**Florida
Power**
CORPORATION

July 14, 1988
3F0788-12

Subject: Crystal River Unit 3
Docket No. 50-302
Operating License No. DPR-72
Emergency Feedwater

CONFIRMATION OF ACTION LETTER

FLOWPATH FOR EMERGENCY FEEDWATER

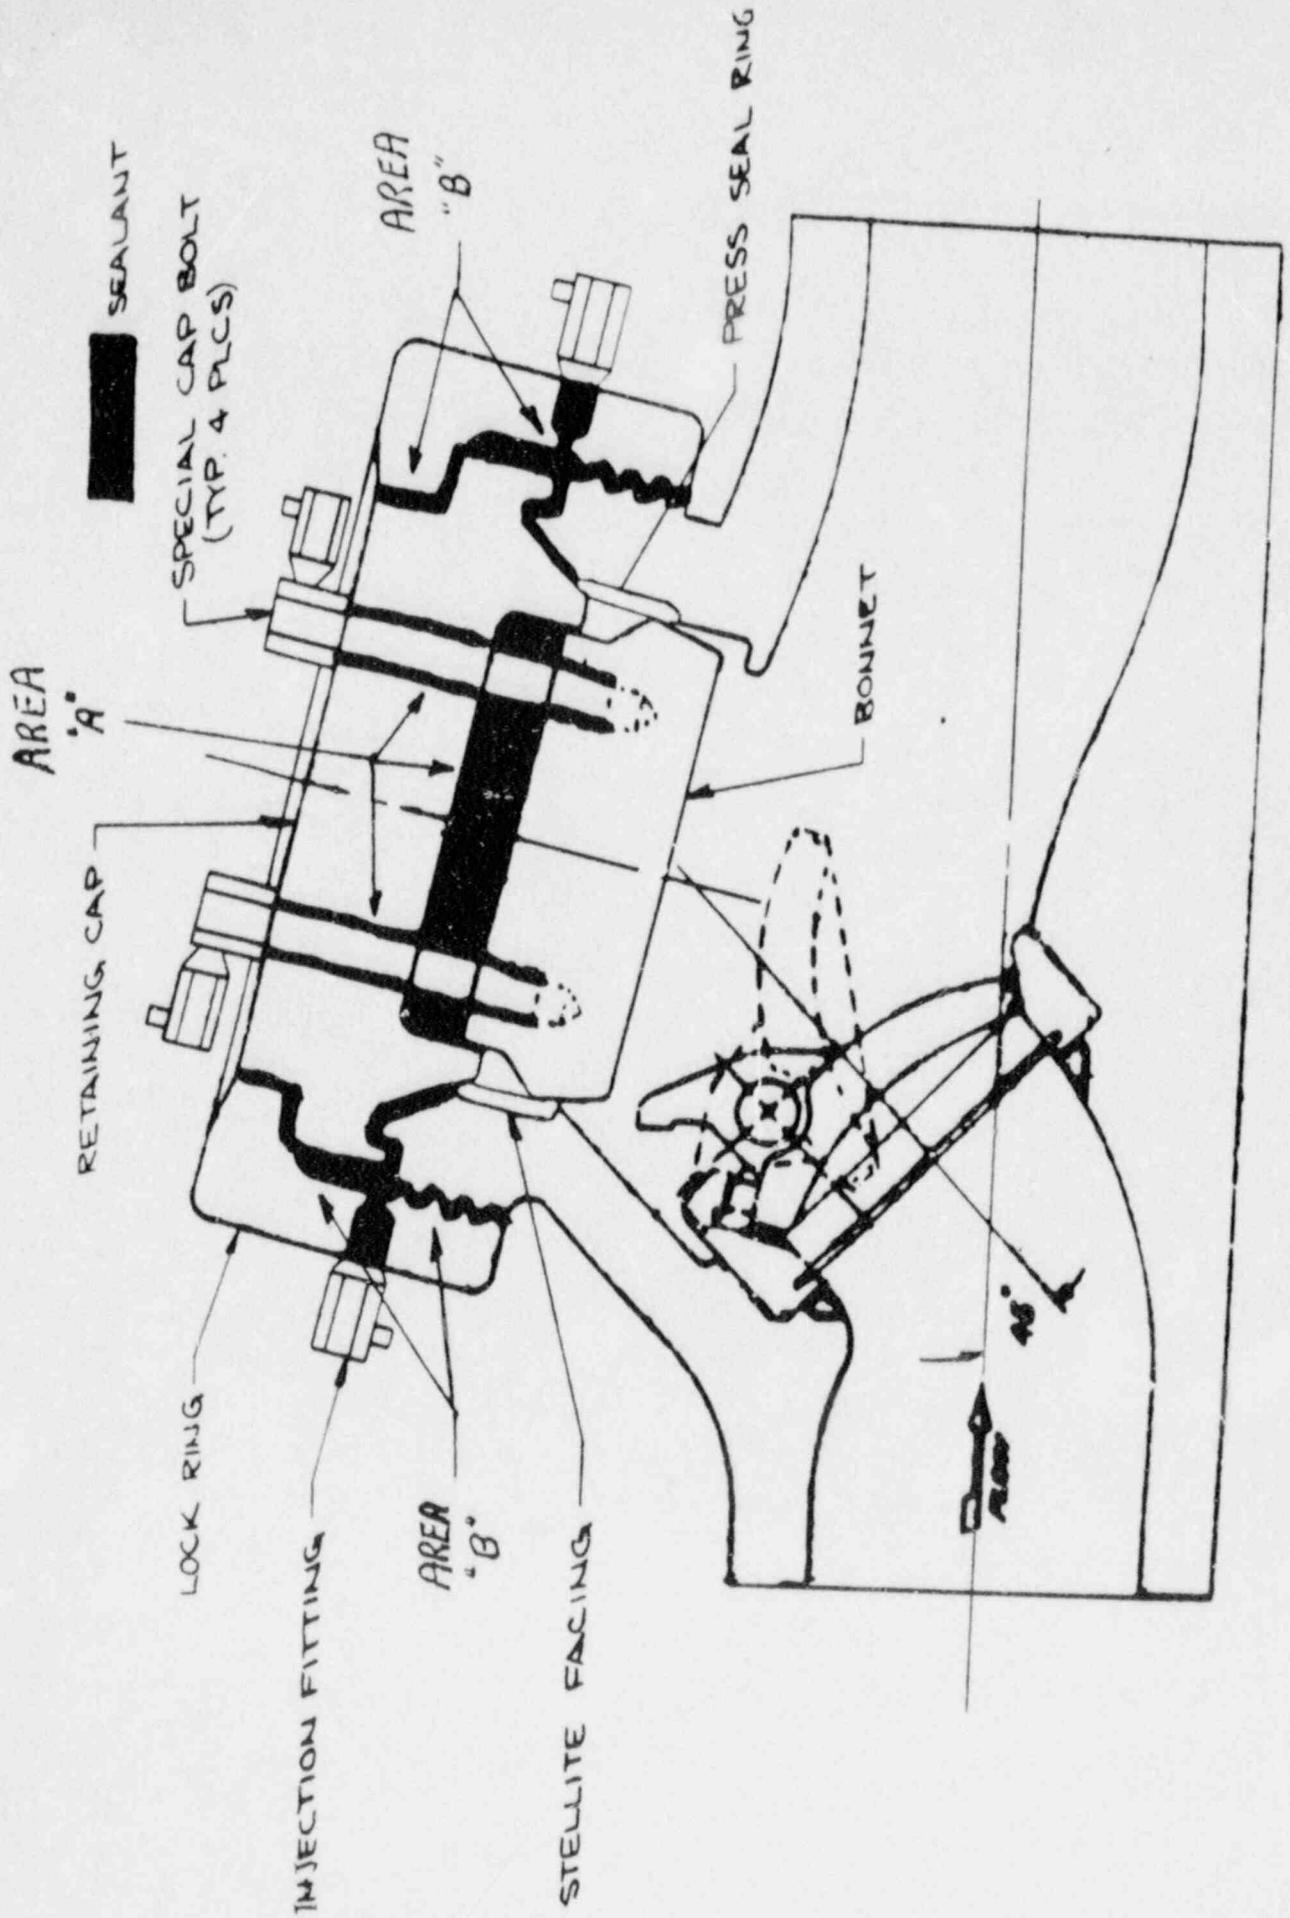
During Refuel VI, several emergency feedwater (EFW) system valves underwent refurbishing. These efforts included the repair of EFV-33 and the inspection of EFV's 15, 16, 17, and 18 (see Attachment 1 flow schematic). Two (2) of these valves, EFV-18 and EFV-33, were identified as having body to bonnet leaks during Refuel VI startup activities on January 7, 1988. Efforts to secure the leaks were unsuccessful. The unit was returned to service on January 10, 1988.
